Development Review Committee (DRC) Meeting

Tuesday, May 21st, 2024 – 9:30 AM

DRC AGENDA

**City of DeBary
Development Review Committee Meeting
April 16, 2024 - MINUTES**

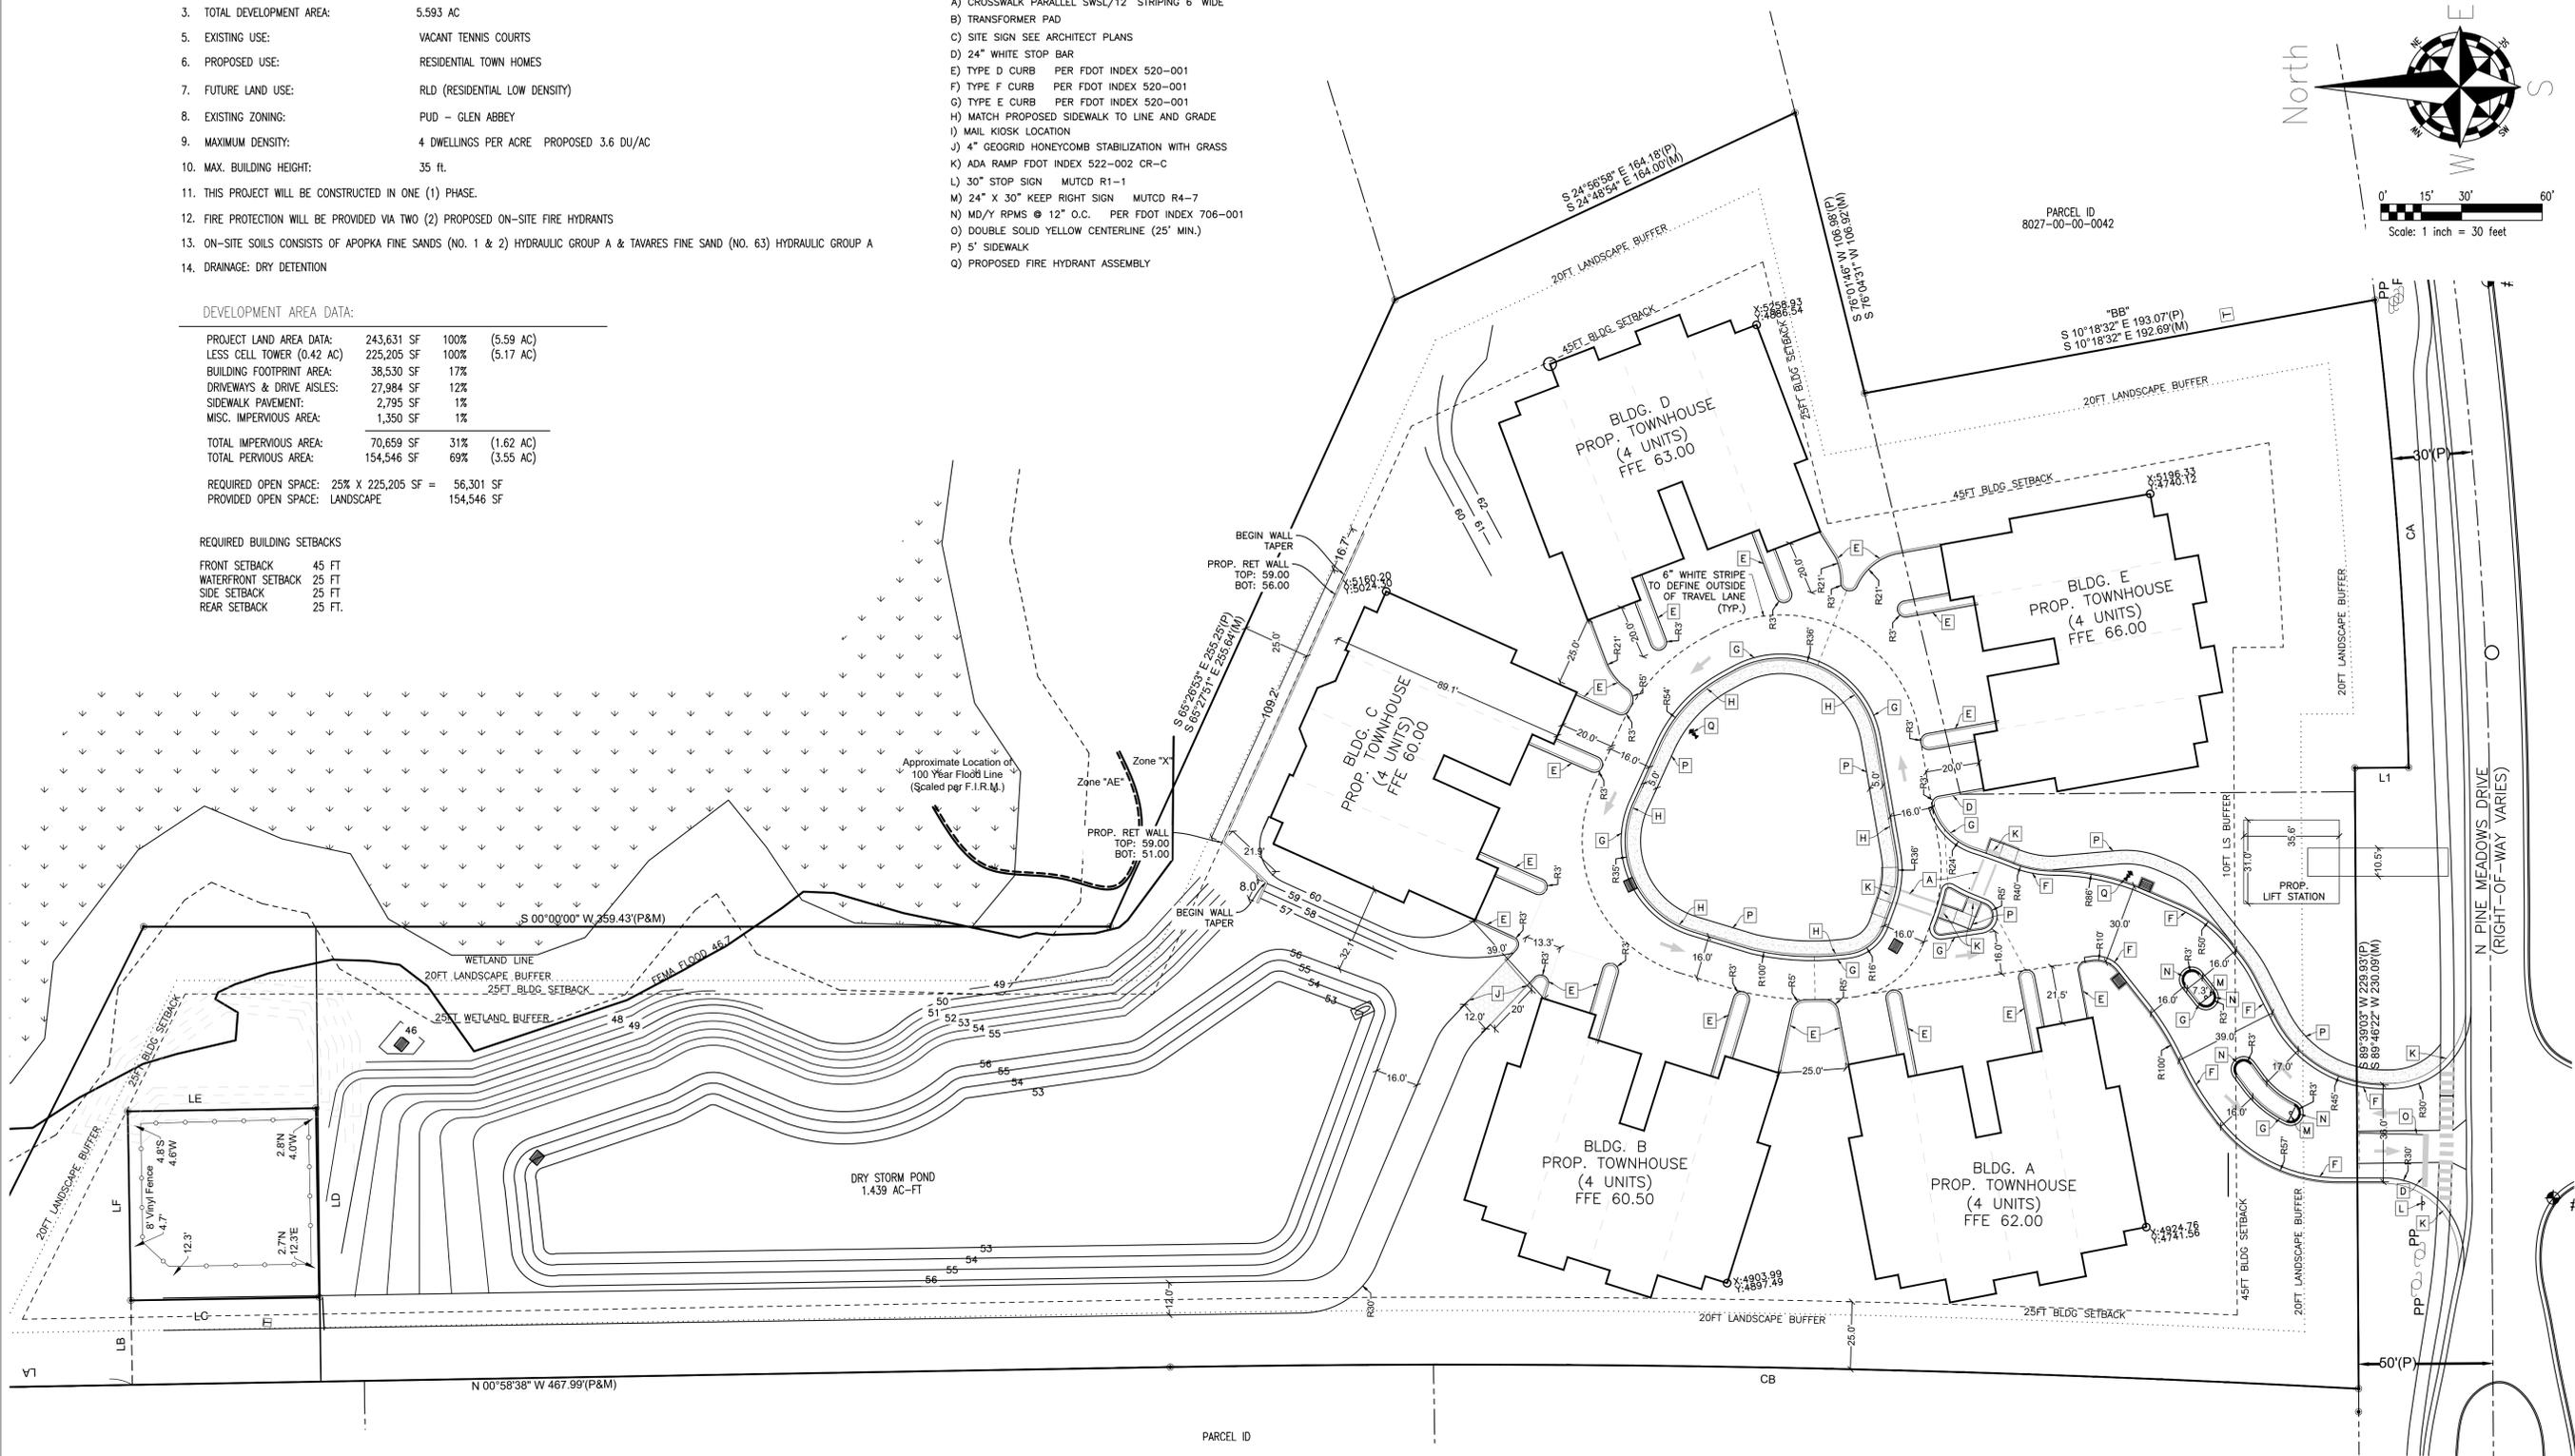
- 1) One way on plan calls for a 16 ft wide road. The Florida Fire Prevention Code 8th ED of NFPA 1 Chapter 18, Section 18.2.3.5.1.1. (Fire access roads shall have an unobstructed width of not less than 20 ft).

C7.0

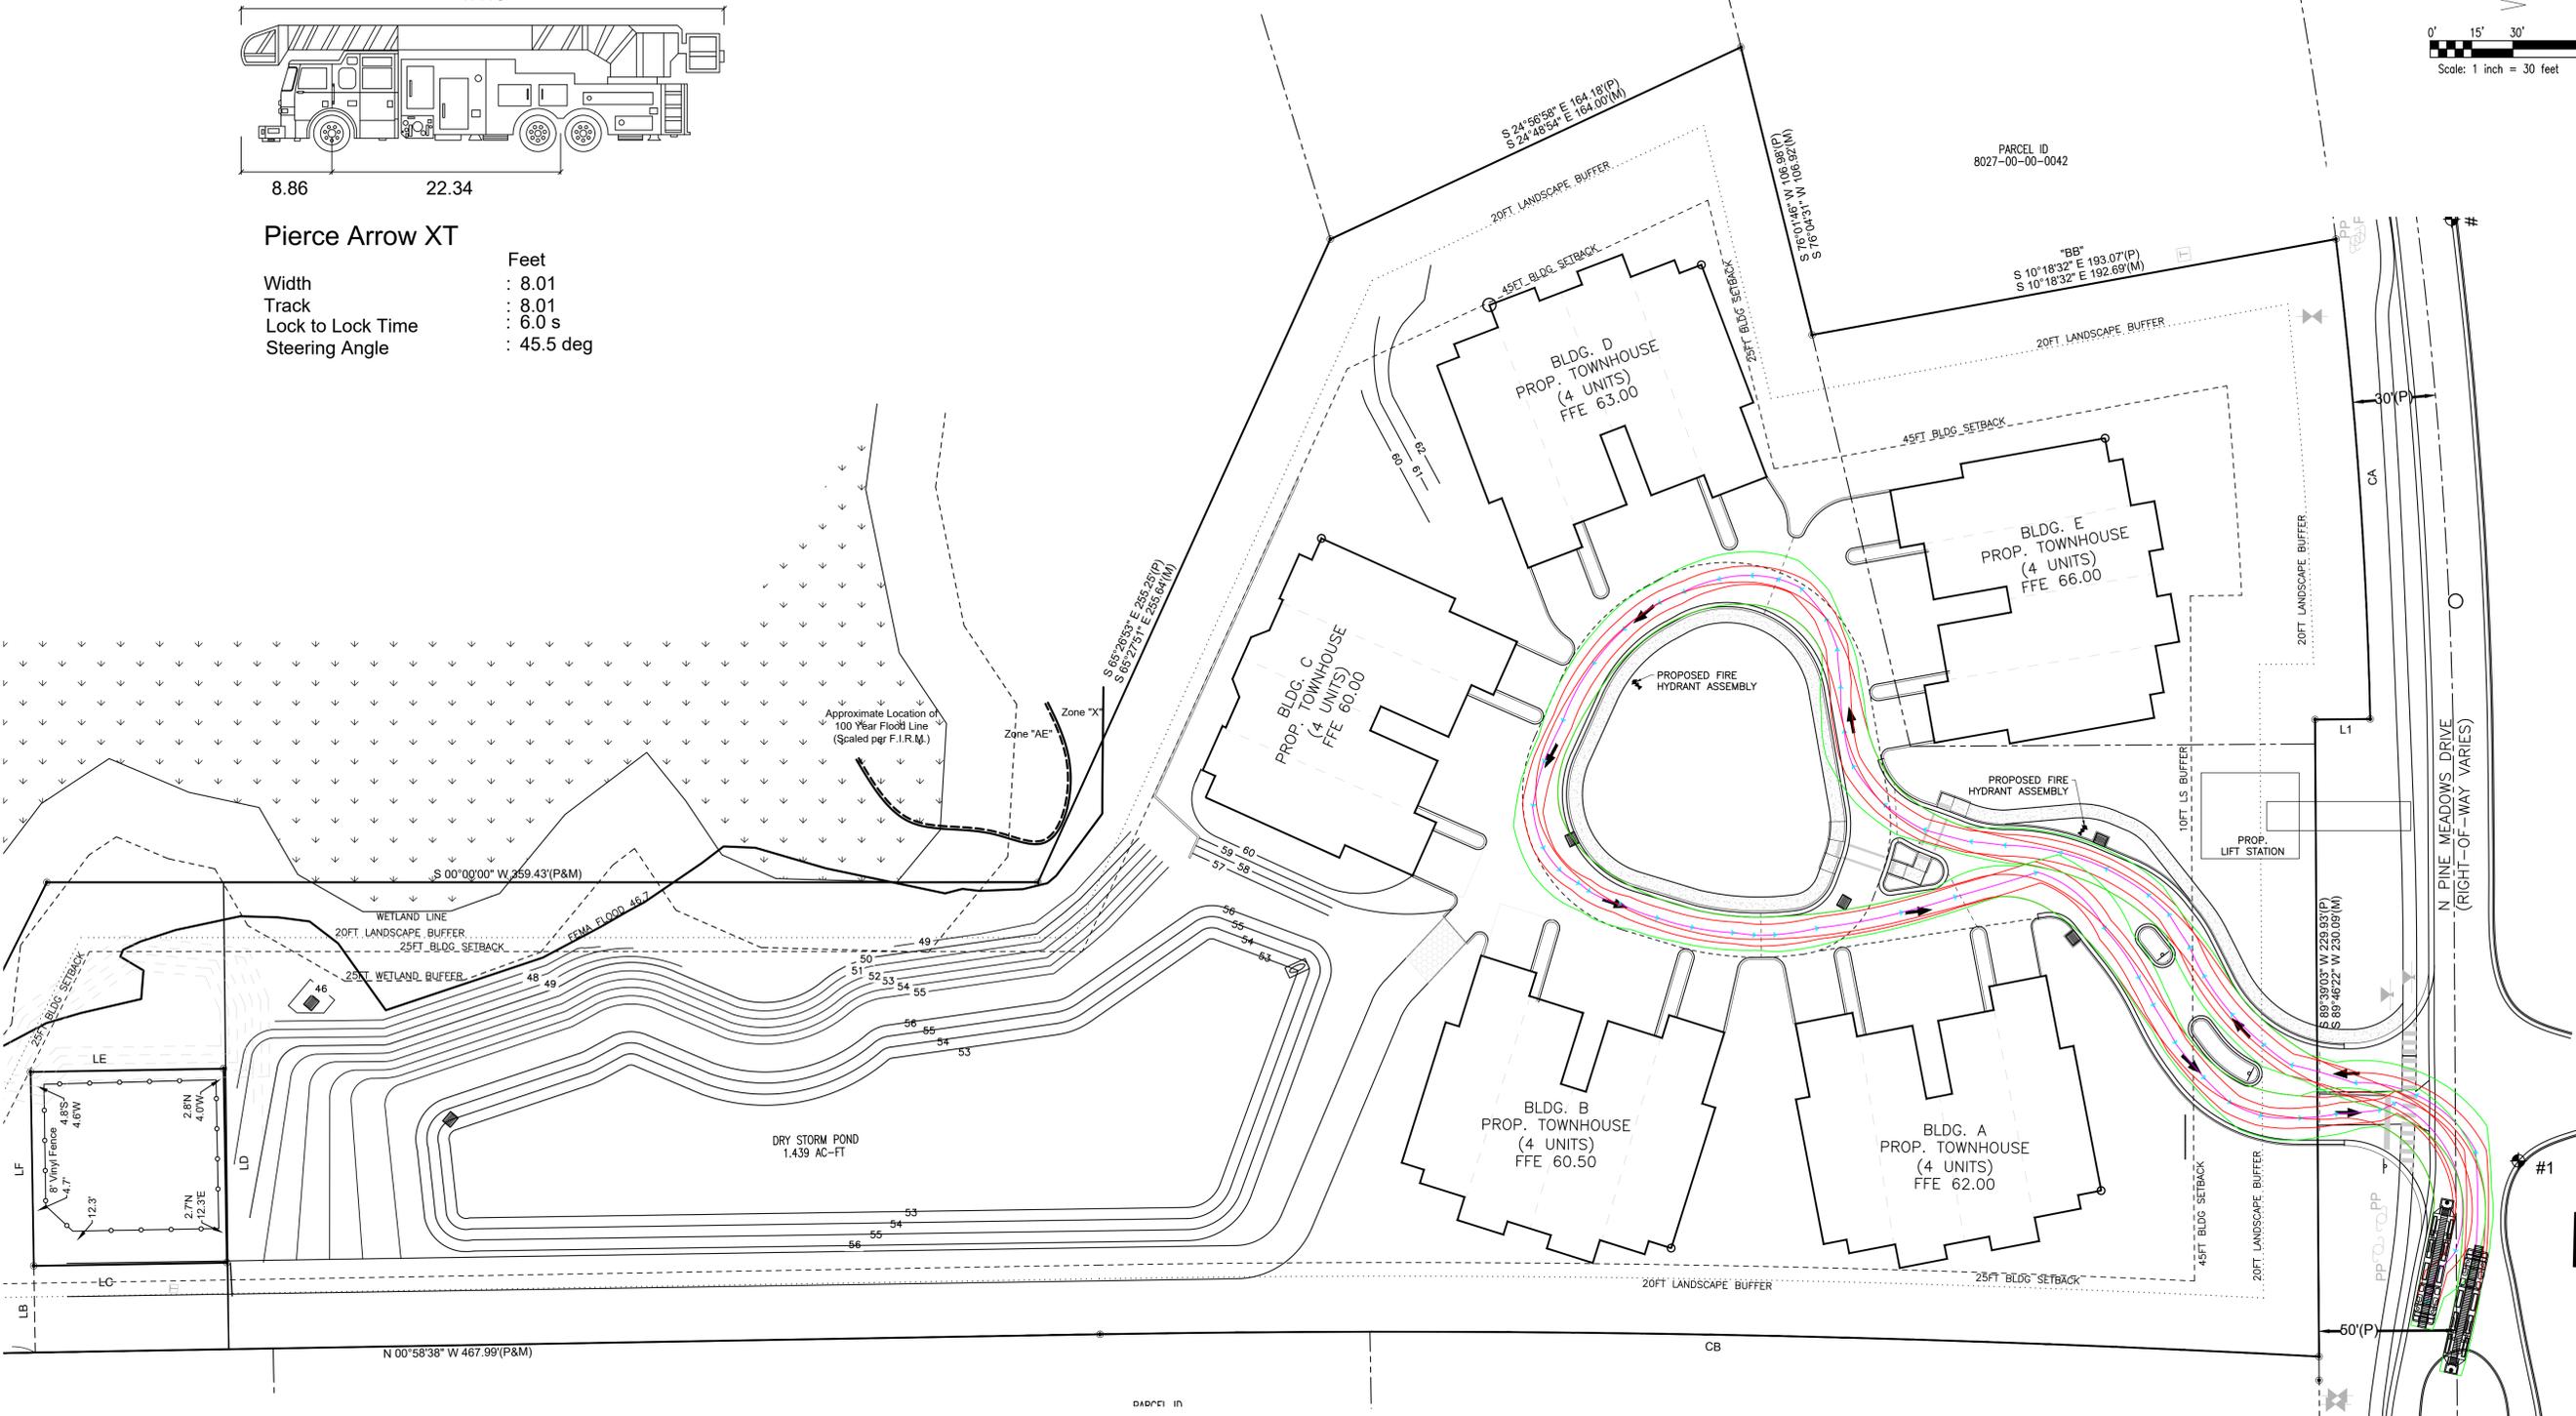
- 4) Provide Fire flow requirements for Project. The Florida Fire Prevention Code 8th ED of NFPA 1 Chapter 18, Section 18.4.5.
- 5) Page C7.0 Shows CAD drawing for Fire Apparatus and shows for Pierce Arrow XT ladder truck. I have provided with this document the correct information for turning radius. The Florida Fire Prevention Code 8th ED of NFPA 1 Chapter 18, Section 18.2.3.5.3.
